Access Compliance Report

Public Rights-of-Way

(Curb Ramps)

Intersection ID: 10570	Main Street: HERRIN_AV	Cross Street: HOLT_ST	Location: SW
ADA ID: 5733C57A46CC	Ramp Type: BlendTrans1	Initial Pass/Fail: Fail	Overall Compliance: No
Codes/Mitigation Info/Possible Solution		Field Measurements/Component Compliance	
Severity Score: 8.75

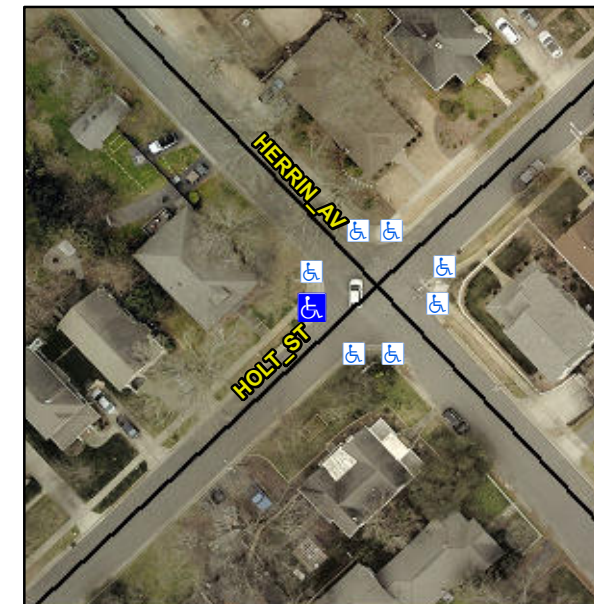
Not Found, R304.5.1

Compliance	Description	Data	Compliance	Description	Data
N/A	Ramp Length (in)	59.0	Yes	BlendTrans Slope (%)	4.8
No	Ramp Width (in)	45.0	Yes	BlendTrans XSlope (%)	0.7
N/A	Flare Type LT	N/A	N/A	Flare Type RT	N/A
N/A	Flare Slope LT (%)	N/A	N/A	Flare Slope RT (%)	N/A
N/A	Flare Traversable LT?	N/A	N/A	Flare Traversable RT?	N/A
N/A	Landing Length (in)	N/A	N/A	DWS Provided?	N/A
N/A	Landing Width (in)	N/A	N/A	DWS Contrast?	N/A
N/A	Landing Slope (%)	N/A	N/A	DWS Length (in)	N/A
N/A	Landing X Slope (%)	N/A	N/A	DWS Full Width?	N/A
N/A	Landing Curb? (Y/N)	N/A	N/A	DWS Offset (in)	N/A
N/A	Shared Landing?	N/A			
N/A	Gutter Ponding?	N/A	N/A	Gutter Slope (%)	N/A
N/A	Gutter Lip Ht (in)	N/A	N/A	Gutter X Slope (%)	N/A
N/A	Painted X Walk1?	No	N/A	Painted X Walk2?	N/A
	X Walk 1 Direction	To SE		X Walk 2 Direction	N/A
	X Walk 1 Width (in)	N/A		X Walk 2 Width (in)	N/A
	X Walk 1 Slope (%)	3.5		X Walk 2 Slope (%)	N/A
	X Walk 1 X Slope (%)	1.5		X Walk 2 X Slope (%)	N/A

N/A	Ramp inside XWalk1?	N/A	N/A	Ramp inside XWalk2?	N/A
	Road Slope (%)	1.5		Clear Space?	N/A
	Road X Slope (%)	3.5	N/A	Clear Space to XWalk (in)	N/A
N/A	Any Obstructions?	N/A	N/A	Storm Grate/Utility Hazard?	N/A
	Obstruction Type			Storm Grate/Utility Type	
		N/A			N/A
			Yes	Surface Condition? (G/P)	Good
			No	Curb Slope (%)	11.6

Remove & Replace Curb Ramp With Two New Directional Ramps or Equivalent.
